Port Colborne 2014 CBRA Update Report

Response to MECP Comments

August 28, 2020

RE: Review Comments on the Revised Port Colborne Community Based Risk
Assessment

MOECC Figure 3: Nickel concentrations in silver maple foliage (ug/g dry weight) from

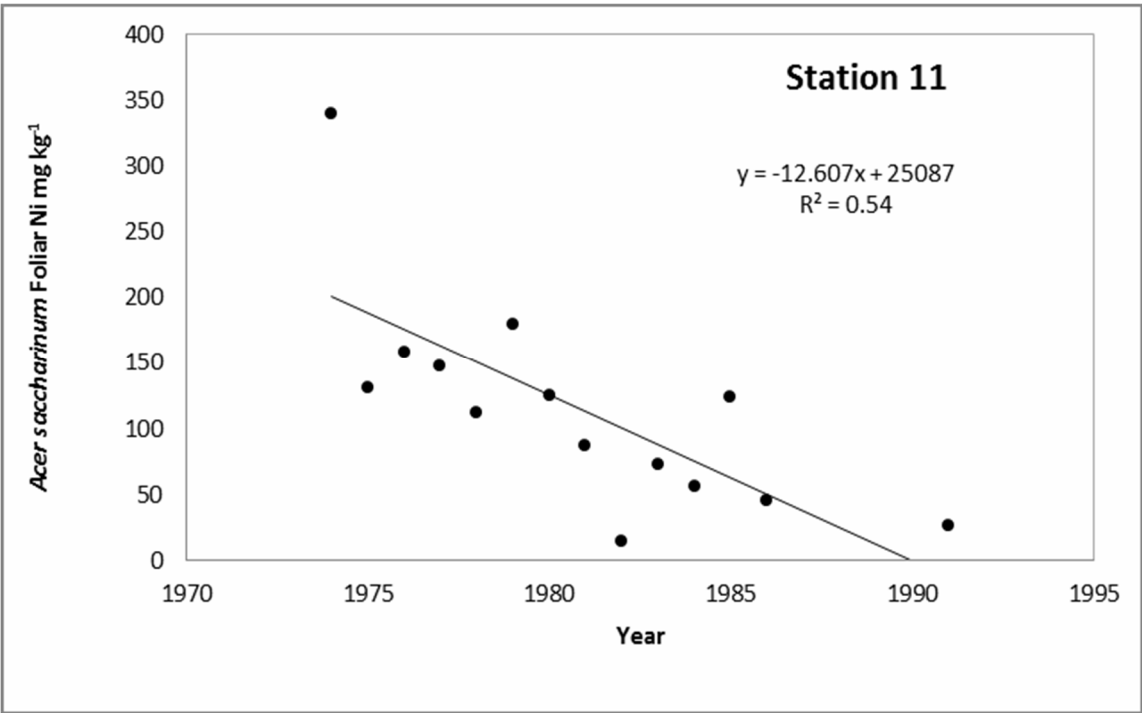
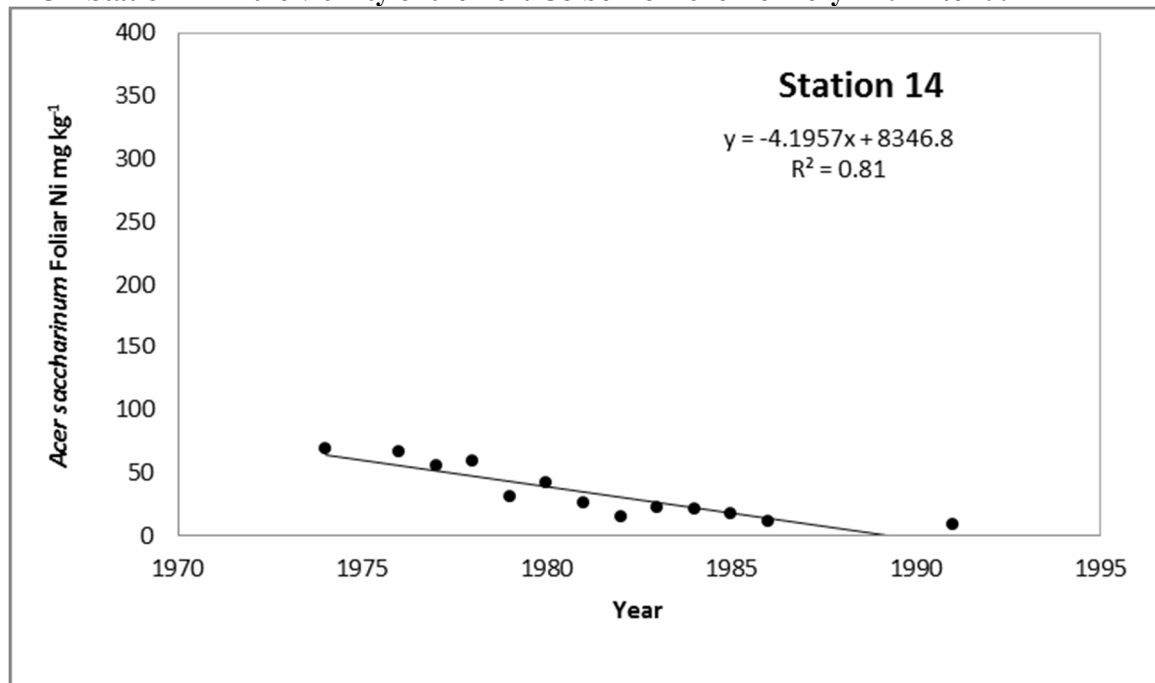
When comparing nickel concentrations in unwashed silver maple foliage collected by the MOE at Stations 11 with Station 14 from 1974 to 1991, it is clear that Station 11 has much higher foliar nickel concentrations and that the decrease in foliar nickel concentrations is much more pronounced at Station 11 than at Station 14 (MOECC Figures 3 and 4).

MOECC Figure A1 Ni Oral TRVs

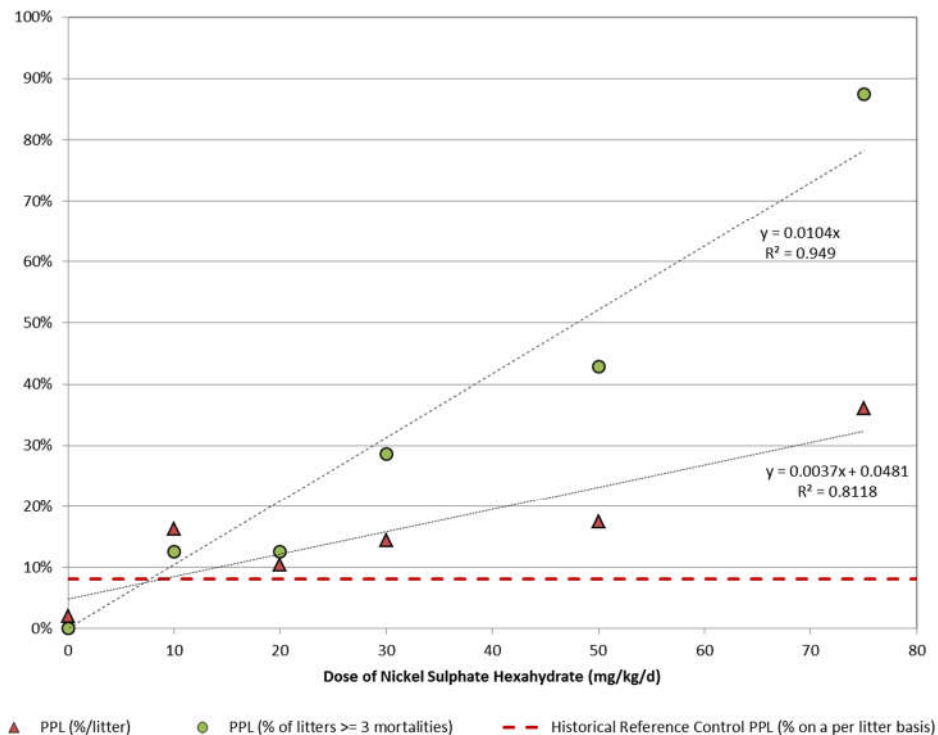
The TRV of 11 µg/kg-bw/day (see TRV “B” in MOECC Figure A1) is supported by Health Canada (2010), WHO (2007), OEHHA (2012) and the analysis conducted by EFSA (2015). This TRV is based primarily on the Springborn (2000 a,b) studies that identified an increased rate of post-implementation loss and perinatal lethality in rats treated by gavage with nickel sulfate (hexahydrate) in drinking water. The TRV was derived from a NOAEL of 1.1 mg/kg-bw/day and the application of a combined uncertainty factor of 100: 10 to account for intraspecies variability, and 10 for interspecies variability.

Recently, the European Food and Safety Authority (EFSA, 2015) reanalyzed the first generation range finding study (Springborn 2000a) and the subsequent full 2-generation study in rats (Springborn 2000b), combining the results from the two studies. EFSA identified reproductive and developmental toxicity as the critical effects for the risk characterization of chronic oral exposure to Ni, and derived a benchmark response at 10% extra risk (BMD_{10}) of 0.76 mg/kg-bw/day) with a lower 95th confidence limit (BMDL_{10}) of 0.28 mg/kg-bw/day), based on post-implantation loss of the combined single data set. Using the derived BMDL_{10} , EFSA estimated a tolerable daily intake (TDI) of 2.8 $\mu\text{g}/\text{kg-bw}/\text{day}$ upon the application of a combined uncertainty factor of 100: 10 to account for interspecies differences, and 10 for human variability (see TRV "D" in MOECC Figure A1).

The MOECC agrees with the approach used by EFSA 2015 of combining the two Springborn rodent studies (2000a,b) and using of benchmark dose response analysis for deriving a TRV. However, the MOECC considers that the application of a total uncertainty factor of 100 to a BMDL_{10} is tending towards an overly conservative consideration for use in the Port Colborne CBRA. For example, the use of BMD_{10} instead of BMDL_{10} would yield a TRV of 7.6 $\mu\text{g}/\text{kg-bw}/\text{day}$ instead of 2.8 $\mu\text{g}/\text{kg-bw}/\text{day}$.

Vale response: EFSA's 2015 BMD analysis is inappropriate. The Benchmark Dose (BMD) approach is a regression approach that was conceptualized as a replacement for the conventional NOAEL/LOAEL approach. The NOAEL/LOAEL approach essentially compares the toxicological response at each dose and compares it with the response in control animals receiving no toxicant exposure. The NOAEL is the highest dose for which the toxicological response is not significantly different from that seen in the control animals. The LOAEL is the lowest dose for which the toxicological response is significantly different from that seen in the control animals. The NOAEL and LOAEL are independent of the toxicological responses observed at other dose levels. In contrast, the Benchmark Dose approach is intended to use the entire range of the dose-response data to develop statistical relationships

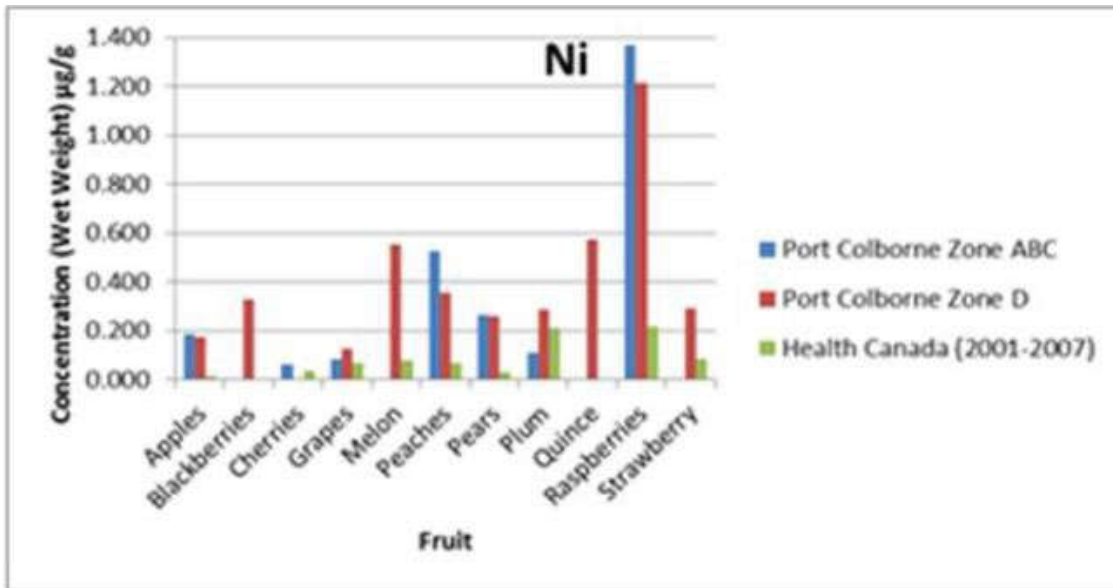
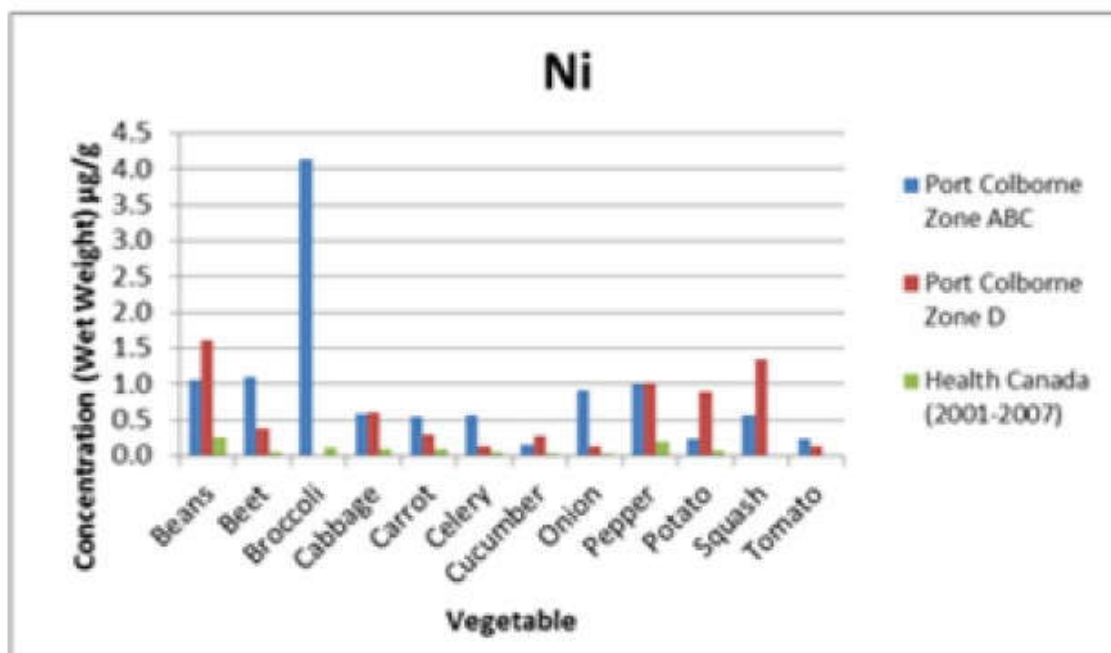
It is clear from MOECC Table B1 that the majority of the samples for the combined zone A, B and C were determined from zone C (which doesn't include the most contaminated residential soil Ni levels). Overall, MOECC is concerned that the limited number of samples from the residential areas in Port Colborne significantly limits the interpretation of these results.

Despite the limitations in the available data for Ni concentrations in backyard garden produce, it is apparent that Ni concentrations are higher in fruits and vegetables from Port Colborne when compared to the average Canadian value. This is demonstrated in the CBRA report in Figure 3B.2 (Comparison of the Average Concentration in Backyard Fruits to the Average Concentration from the Health Canada Total Diet Study, 2001-2007) and Figure 3B.3 (Comparison of the average concentration in backyard vegetables to the average concentration from the Health Canada Total Diet Study, 2001-2007). These Figures are included below.

It is noteworthy that Ni levels are elevated even in samples collected from Zone D, an area with lower Ni soil contamination than found in Zone B. In addition, in some cases, there is very high uncertainty in the estimated Ni concentration in specific produce as the results are based on only one sample (e.g. the concentration for broccoli in Figure 3B-3 is based on a single sample). Another concern with the sampling design is that the majority of the data is for soils with Ni concentrations less than 1,500 mg/kg. No data is available for Ni levels in local garden produce when Ni soil concentrations exceed 6,680 mg/kg. According to the CBRA report (HHRA 2007), soil concentrations are a poor predictor of produce concentration; however, some relationships between soil Ni concentration and Ni concentrations in fruit (Peaches, Plums, and Strawberries) and vegetables (leafy vegetables, rhubarb) were identified in the CBRA report. A positive correlation of higher Ni in plants at higher soil Ni concentrations would be expected based on the results of the Crops ERA. While the backyard garden sampling was designed to represent community exposure, the available data does not reflect the upper end of expected soil Ni levels that can occur in residential gardens in Port Colborne (See MOECC Table B2 below). In addition, there is no information on the potential exposure to Ni from locally grown garden produce at the soil concentrations recommended in the CBRA report at the RBSCs (i.e., 48,000 mg/kg Ni in Zone B). Therefore, in absence of additional sampling, caution is warranted in using this information as part of developing the RBSC and in applying the recommended RBSC (that has not considered the potential for backyard garden produce grown in soil conditions at the RBSC) to contribute to the total dietary exposure.

Figure 3B.7: Concentrations of Nickel in Supermarket Food

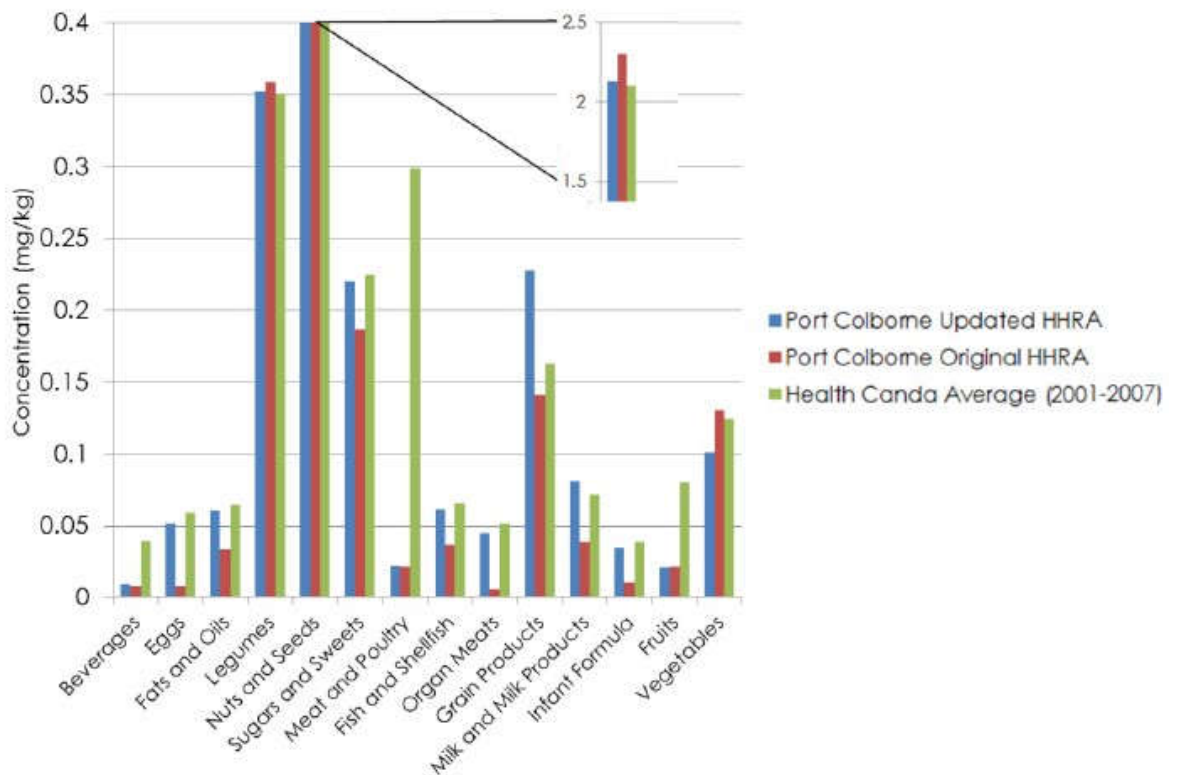
For the supermarket exposure, the revised estimate developed by Stantec for Ni levels in various food products incorporates Port Colborne data supplemented with the Canadian data. This was done by Stantec using the following protocol: (1) for food categories with less than 10 samples, food concentrations were based on the average of the Port Colborne study but supplemented with the Canadian yearly averages (developed from a total of 8 data sets between 2001 and 2007) and (2) for food categories with 10 or more samples, concentrations food concentrations were estimated based on the higher of the upper confidence level of the (geometric) mean and the 75th percentile from the Port Colborne data only. As demonstrated in the CBRA report in Figure 3B.7 (Concentrations of Nickel in Supermarket Food), Ni concentrations used in the CBRA are generally similar to the Canadian average (2001-2007). However, notable exceptions are apparent where lower Ni concentrations are observed for the Port Colborne estimate for beverages, meat and poultry, and fruits (Figure 3B.7 provided below). For these food categories, it is unclear why the Port Colborne data should be lower than the Canadian average and raises questions regarding the adequacy of this Port Colborne specific Supermarket data to properly represent the community supermarket diet. It is noteworthy that consistent with the findings from the Crops ERA, higher Ni concentrations were observed for the Port Colborne estimate for the grain products food. The food categories beverages and meat and poultry are discussed in more detail below.

MOECC Figure C1

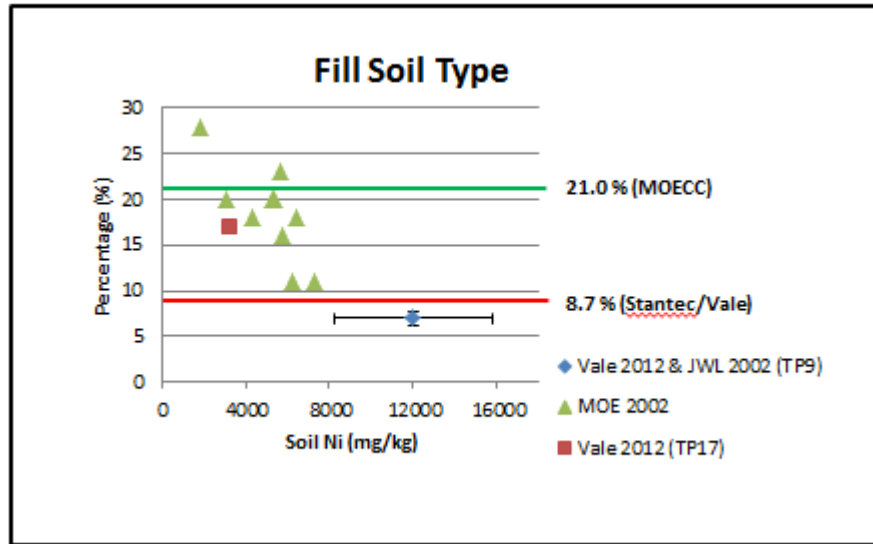
There appears to be a relationship between Ni bioaccessibility and soil Ni concentration where Ni bioaccessibility is higher at lower soil Ni levels (MOECC Figure C1). This relationship can be statistically determined with high confidence (see Section 3 below). However, MOECC believes that a reasonable conservative (i.e., erring on the side of caution) estimate is to use the 95% UCLM (an upper estimate of central tendency). This is consistent with the MOECC practice for all risk assessments. Using all of the bioaccessibility data (including the data from Exponent, 2002) results in a 95% UCLM of 21% for fill soils (see MOECC Figure C1 and Table C2 below). Note: this recommended bioaccessibility estimate captures the range of bioaccessibility for soils with Ni concentrations <8,000 mg/kg (which range from 11 to 28%).

Vale Response: *As mentioned in the previous response, the Ministry's data overestimate (provide a conservative estimate of bioaccessibility).*

MOECC Figure C2

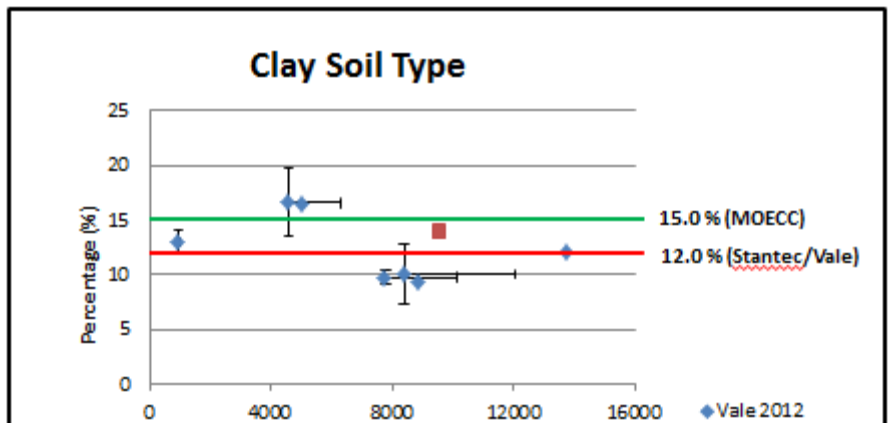
As with the fill soil type, many of the clay soil samples were taken from the same sampling location suggesting a greater number of soil locations than actually tested and raising concerns with treating the bioaccessibility estimates from the same location as independent discrete samples. As a consequence, the clay bioaccessibility data were re-analyzed by MOECC by sample location (MOECC Figure C2). It should also be noted that the amount of bioaccessibility information for the clay soils is vastly improved over previous versions of the CBRA. Instead of only one soil location, information is now available for 8 locations.

Contrary to the results for the fill soil, there does not appear to be a relationship between Ni bioaccessibility and soil Ni concentrations. However, as with the fill soil, MOECC believes that a reasonable conservative estimate is to use the 95% UCLM. Using all of the bioaccessibility data (including the data from Vale 2012) results in a 95% UCLM of 15% for clay soils (see MOECC Figure C2 and Table C3 below). Note: this recommended bioaccessibility estimate captures the range of bioaccessibility for clay soils with Ni concentrations <8,000 mg/kg (which range from 10 to 17%).

Vale Response: *Vale recognizes that these samples were from a small number of test pits. The samples were archived and had been characterized in the CBRA and were available to conduct a bioavailability study.*

MOECC Figure D2

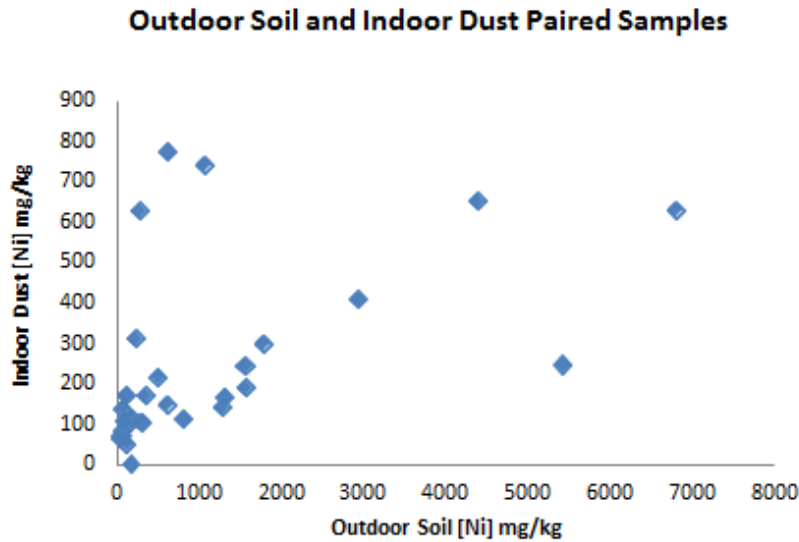
However, most of the data is for soil Ni concentrations below 1,500 mg/kg (n=21 of 28 samples). The large variability of the Ni in indoor dust to Ni in outdoor soil ratio in these samples is also clearly evident at Ni concentrations < 1,500 mg/kg ranging from 0.1 to 2.3. The limited number of samples at the higher soil Ni concentrations (n = 6 for Ni > 1,500 mg/kg; n = 4 for Ni > 2,000 mg/kg) is insufficient to properly characterize the variability and uncertainty inherent in this ratio and severely limits meaningful statistical interpretation of this data at these Ni concentrations. An indication of this variability can be seen when the actual dust and soil data is plotted (MOECC Figure D2).

MOECC Figure D3

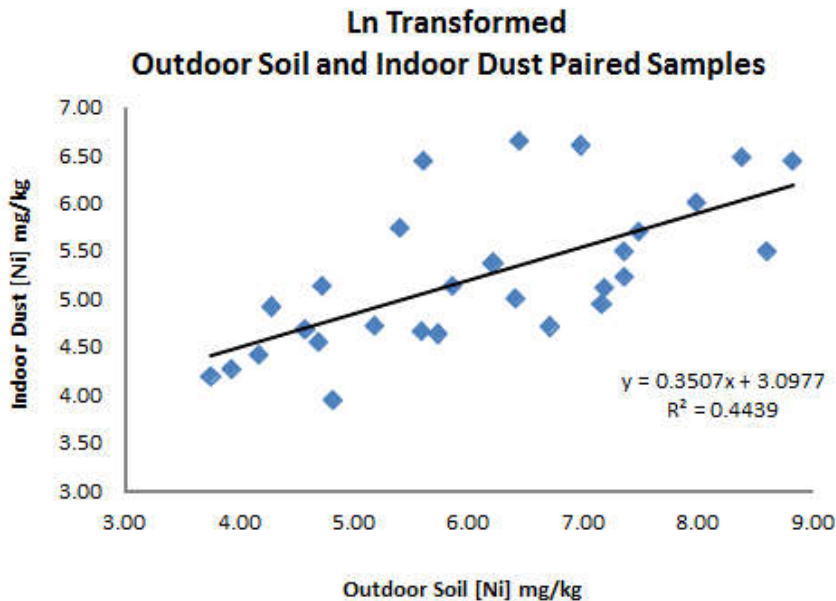
While a weak linear relationship can be determined ($r^2 = .44$) when comparing the natural log of Ni in indoor dust to the natural log of Ni in outdoor soil (MOECC Figure D3), this plot clearly illustrates the high variability in this relationship.
